Murray Valley Proposed Floodway Network

Proposed floodplain boundary and floodway network around [REDACTED]

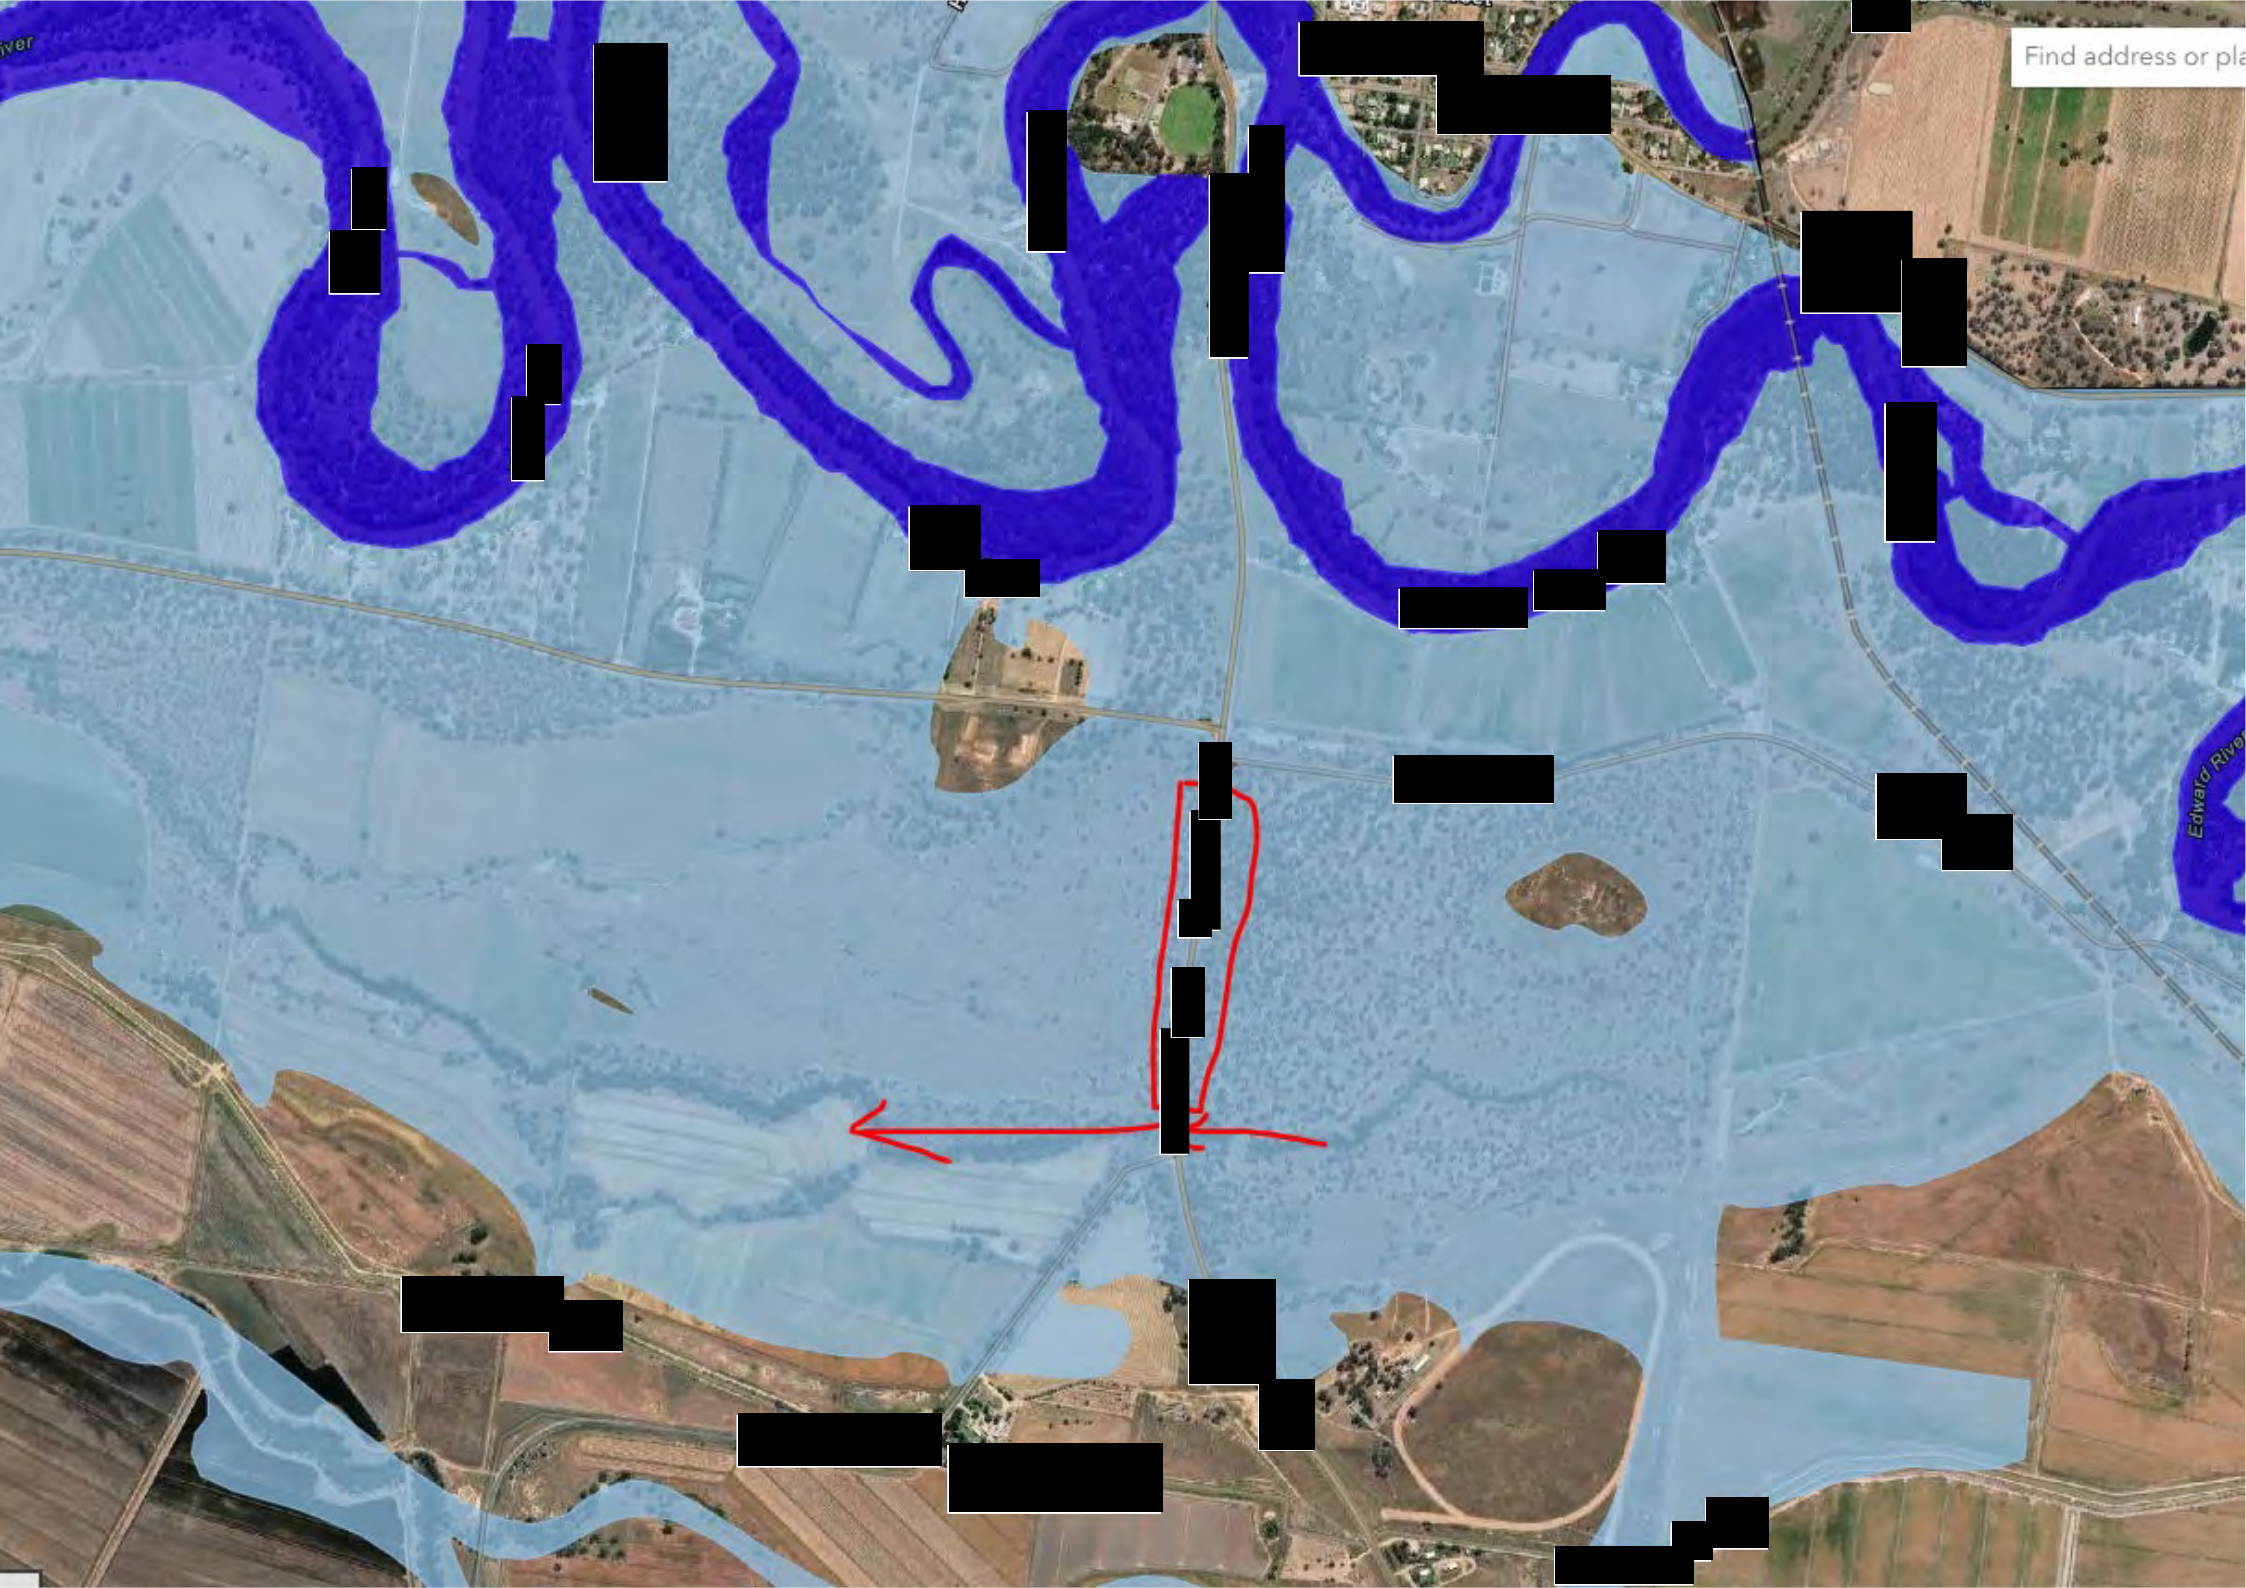
New bridge (1982) good  
height but width  
impact flow of flood  
water

replaced with  
one pipe (in  
the 90s)  
causing major  
flooding)

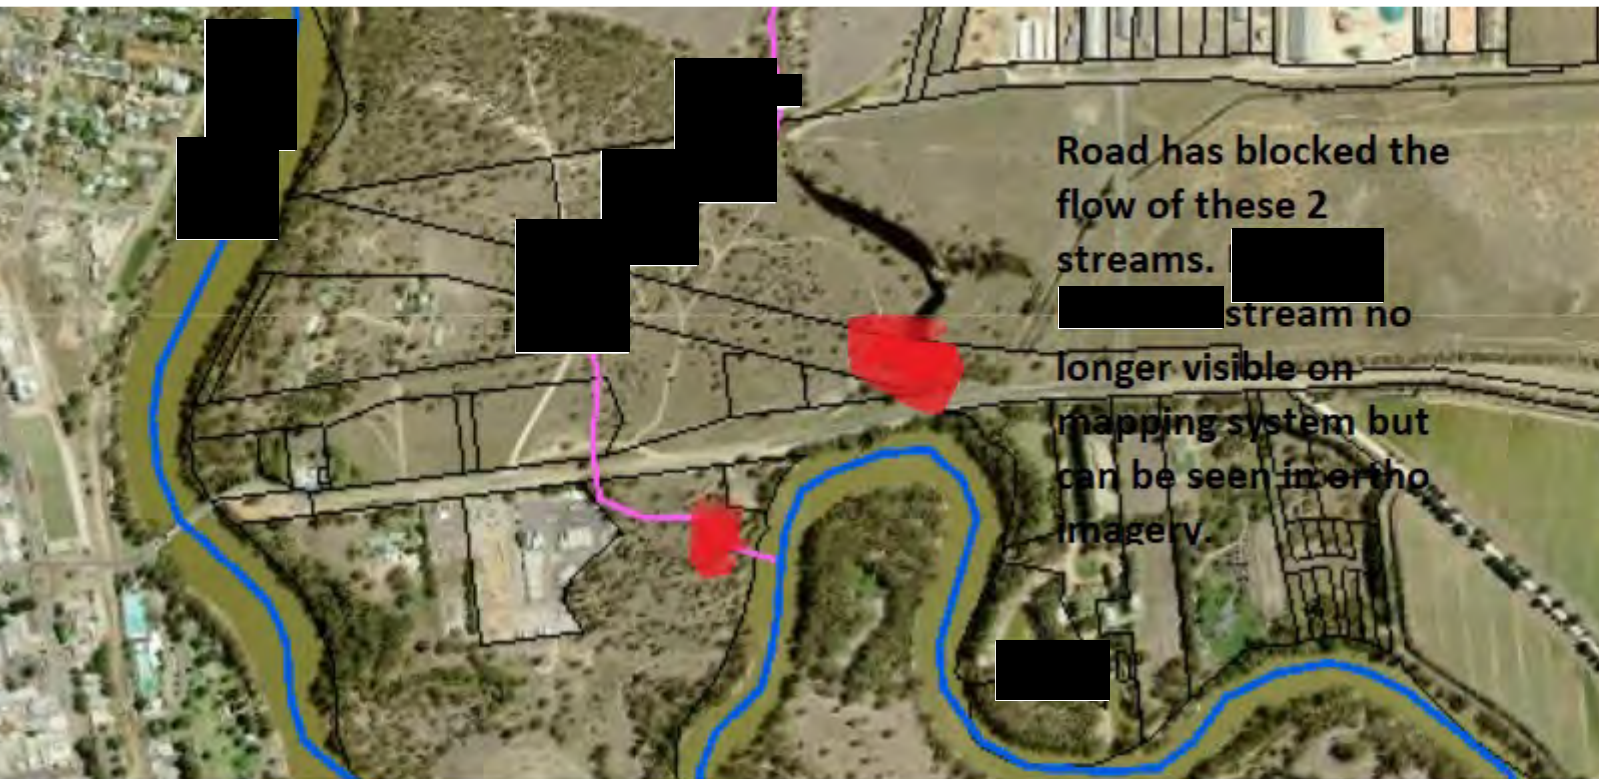
Road has blocked the  
flow of these 2  
streams. [redacted]

[redacted] stream no  
longer visible on  
mapping system but  
can be seen in ortho  
imagery.

New bridge (built 2016)

Too low and causes  
flooding over road.

Length of road goes  
under during flood. Too  
low and no  
causeway/culverts to  
manage water.
